# Marvel-Schebler/Tillotson

## SERVICE BULLETIN

### #A1-82

SUBJECT: Drain Plugs. Model HA Carburetors

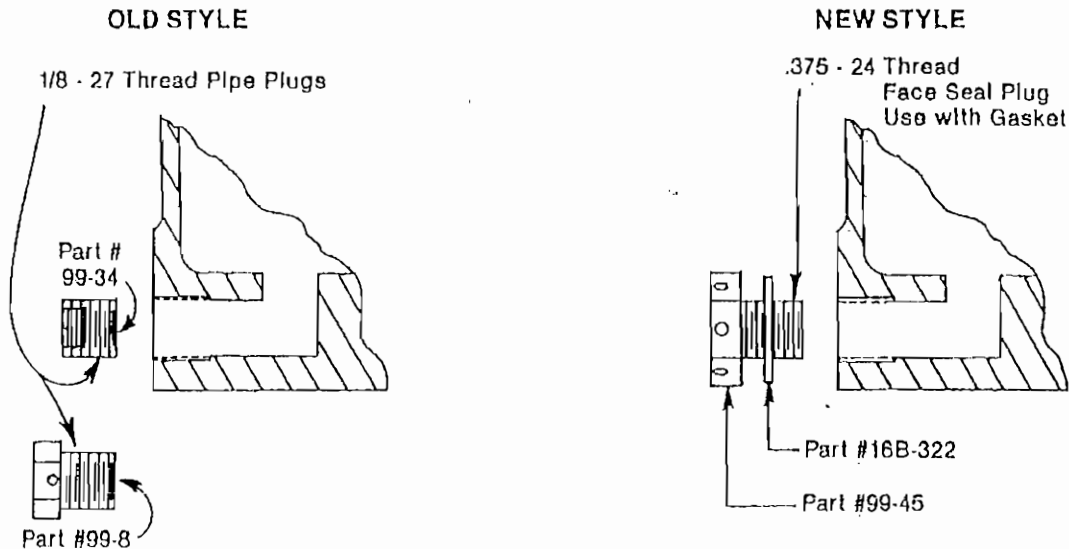
Some difficulties were experienced in removing the recessed allen type drain plugs, Part #99-34. The design has been changed to use a face seal type Part #99-45 with Gasket #16B-322.

THESE ARE NOT INTERCHANGEABLE.

—Note the difference in thread—

Pipe Plug style drain plugs and face seal style are not interchangeable. It is easier to remove and install the #99-8 Hex Head type when you service the old style.
